**CULTURAL RESOURCES OFFICE
 PRESERVATION BOARD
 REGULAR MEETING
 MONDAY AUGUST 23RD, 2010
 1015 LOCUST ST. #1200
 4:00 P.M.**

PRELIMINARY REVIEWS	PG.
A. <u>6021 KINGSBURY</u>SKINKER-DeBALIVERE HISTORIC DIST.	1
B. <u>1922-24 PARK</u>LAFAYETTE SQUARE HISTORIC DIST.	6
C. <u>2007 S. COMPTON</u>COMPTON HILL HISTORIC DISTRICT	14
D. <u>4248 COTTAGE</u>VILLE HISTORIC DISTRICT	18
APPEALS OF STAFF DENIALS	
E. <u>2841 SHENANDOAH</u>FOX PARK HISTORIC DISTRICT	25
F. <u>3219-21 N. 20TH STREET</u>MURPHY-BLAIR NAT'L REGISTER DIST.	29
G. <u>2217 S. JEFFERSON</u>FOX PARK HISTORIC DISTRICT	37
H. <u>2861-69 McNAIR</u>BENTON PARK HISTORIC DISTRICT	43
I. <u>5261 WASHINGTON PLACE</u>CENTRAL WEST END HISTORIC DISTRICT	47
<u>SPECIAL AGENDA ITEM</u>	52
<hr/>	
Petition to extend the boundaries of the Fox Park Local Historic District

DATE: August 23, 2010
FROM: Bob Bettis, Preservation Planner, Cultural Resources Office
SUBJECT: Preliminary Review of an application to install vinyl windows on front façade.
ADDRESS: 6021 Kingsbury Blvd.
JURISDICTION: Skinker-DeBaliviere Local Historic District — Ward 28

6021 KINGSBURY

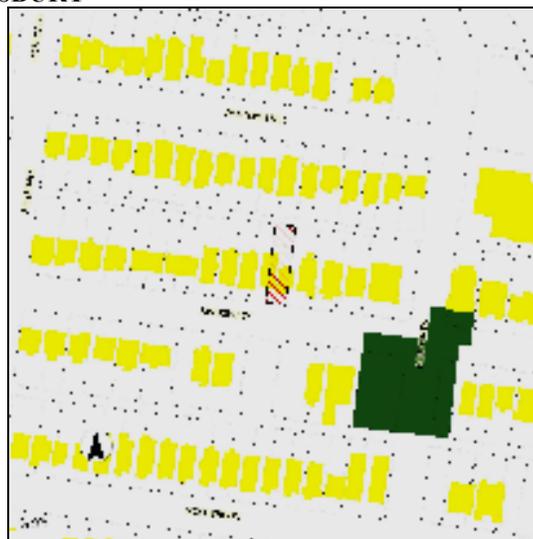
Does not comply. The proposed replacement windows do not replicate the proportions and appearance of the original windows.

windows would seriously affect the building's historic character and integrity. The windows are flat and contemporary in appearance; the lift and meeting rails are narrower, and the jambs are wider than the original window.

The Cultural Resources Office recommends that the Preservation Board deny the Preliminary Application as the vinyl windows do not meet the Skinker-DeBaliviere Historic District Standards.

PARK AVE. ELEVATION

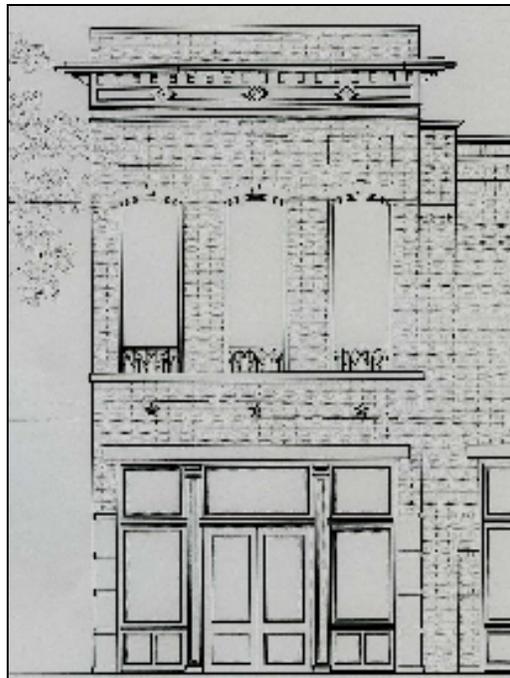
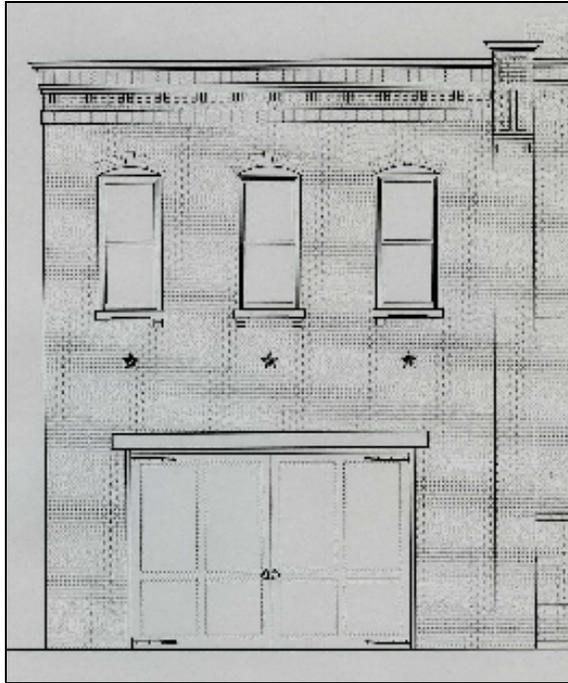
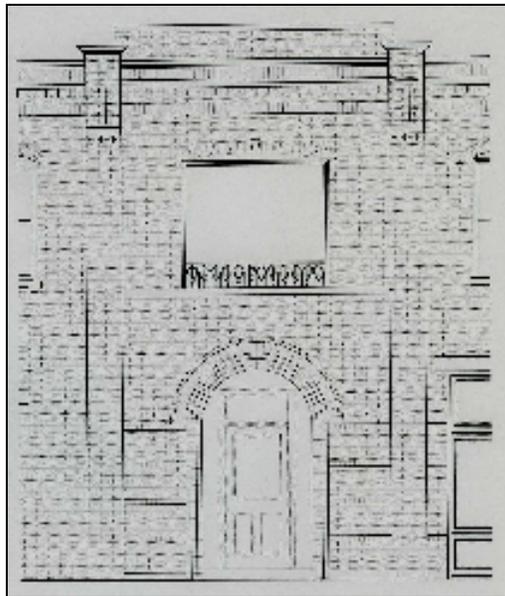
Complies. The building's first floor level is similar to the adjacent buildings.

Complies. The building's height above grade and floor height appear similar to adjacent buildings.

Complies. Both Public Facades comply with these requirements.

Complies. At this time, all four facades are proposed to have brick.

The Cultural Resources Office staff recommends that the Preservation Board grant preliminary approval to the project, with the stipulation that the Cultural Resources Office approve the design of the east and south elevations.

PROPOSED DORMER AND ROOF ALTERATION

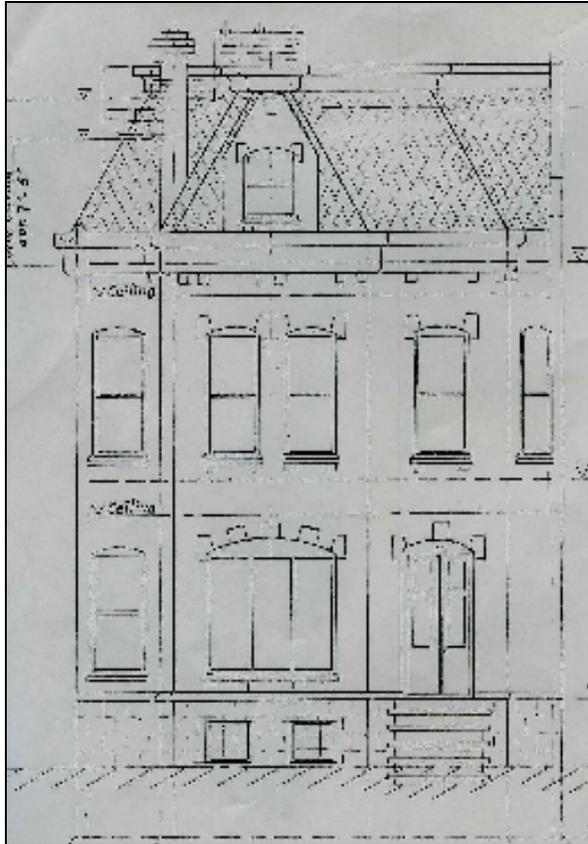
Does not comply. The owner is proposing to install a front facing dormer where one was not located prior. In addition, the alteration to the Mansard roof will also be a violation of the Compton Hill standards. The new Mansard will be largely narrowed and out of scale with the rest of the building and the other houses on the block.

Does not comply. The dominant type of Mansard roof on the block is short, while the proposed roof extension would be taller than the majority on the street.

2007 South Compton, constructed in 1895, is an excellent example of the Second Empire style. The proposed work will significantly alter the appearance of the home. Mansard roofs along this block are squat and don't have the height that is being proposed by the applicant. The overall scale of the Mansard distorts the historic proportions of the building.

To date, the owner has not spoken with the Building Division to see if the current plans meet code. The owner has also recently stated that he may attempt to leave the front mansard height intact and install a dormer within the current configuration. Either proposal will not conform to the local historic district standards.

Staff recommends that the Preservation Board deny the Preliminary Application as the proposed work is not in compliance with the historic district standards.

PROPOSED STORAGE BUILDING

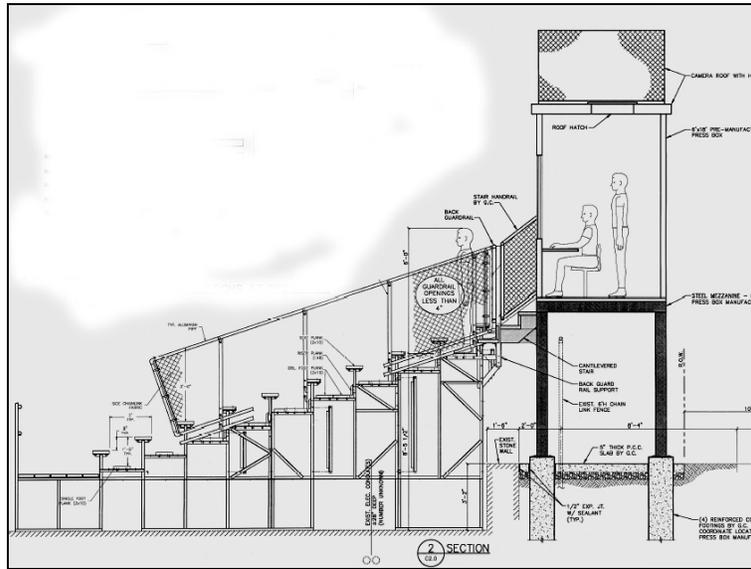
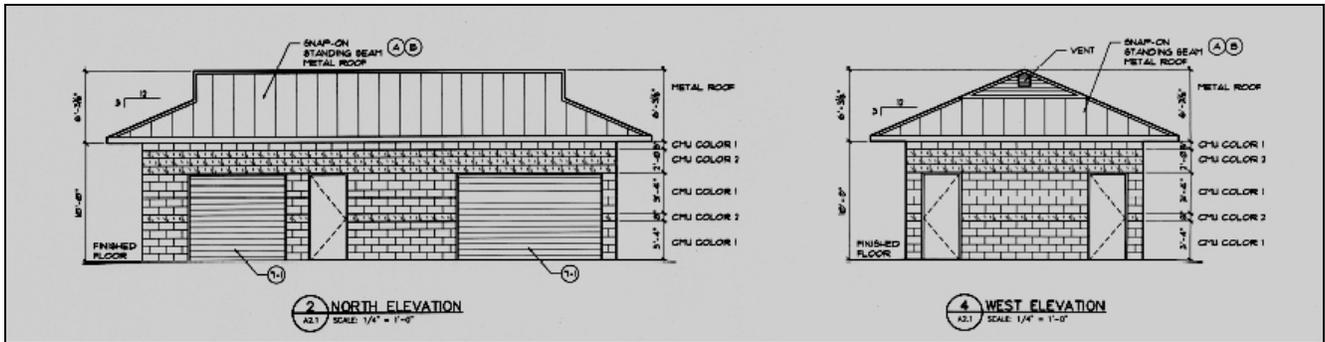
Complies. Exterior building materials are masonry units in colors similar to those of Sumner High School.

Complies. Proposed rooflines of the new buildings are hipped and reminiscent of small single-family buildings in the district.

The original design of proposed ancillary buildings shown to the Cultural Resources Office staff had two choices for exterior material color. The staff recommended that the second option, that incorporates red and limestone-colored masonry block, to reflect the red brick and limestone trim of Sumner. The original proposal was to have the standing seam metal roofs reflect the school colors, maroon and gray. The staff recommended that the roof material be a gray color, again to reflect the roof of the school, and that if desired, the Bull Dog insignia could be applied to the roof. The applicant has agreed to these conditions and will present revised drawings to the Board this evening.

The Cultural Resources Office staff recommends that the Preservation Board grant preliminary approval to the project, subject to the revised exterior materials and roof color.

ORIGINAL DOOR

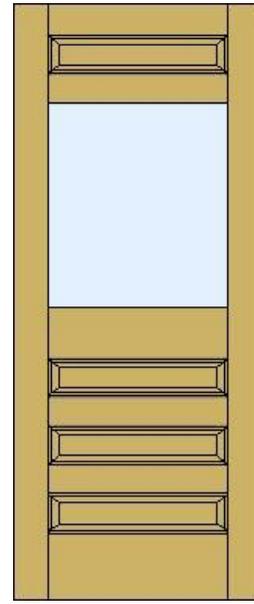
The Cultural Resources Office believes that the proposed door does not replicate the original door closely enough to meet the Fox Park Historic District standards. The glass in the proposed door is 4 ½” inches taller than in the original door, which will significantly change the look when viewed from the street. The two panels in the proposed door are vertical, which is very different from the three rows of three panels present in the original door. The door proposed by the Cultural Resources Office attempts to approximate the original glass size and feel of the original panels. The price of the alternate door would allow approximately \$500 for installation, without exceeding the cost of the door proposed by the owners.

The Cultural Resources Office is asking that the Preservation Board uphold the staff denial as the replacement door does not meet the Fox Park Historic District Standards.

REAR ELEVATION

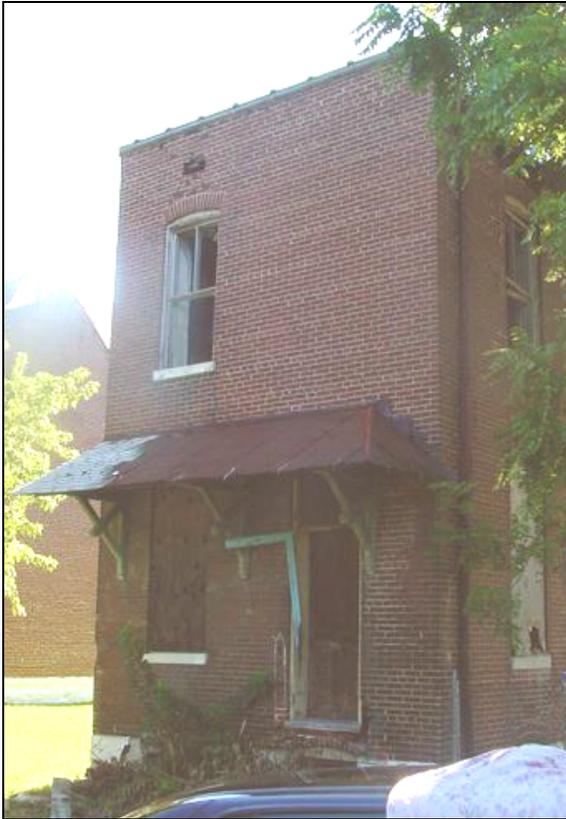
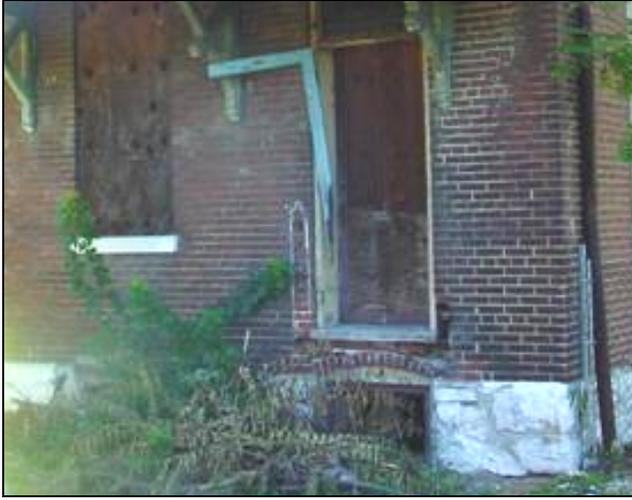
3219-21 N. 20th Street is considered “sound” under the definition of the Ordinance, although it is deteriorated and suffers from a lack of maintenance. All exterior walls are intact with only minor loss of brick at the rear elevation where door framing has been removed. The two-story frame porch on the south elevation is in poor condition.

Note the only masonry deterioration is at the rear door beneath the porch, where framing has been removed.

The appeal of the staff denial should be denied by the Preservation Board as the owners have not met the Ordinance standards for approval.
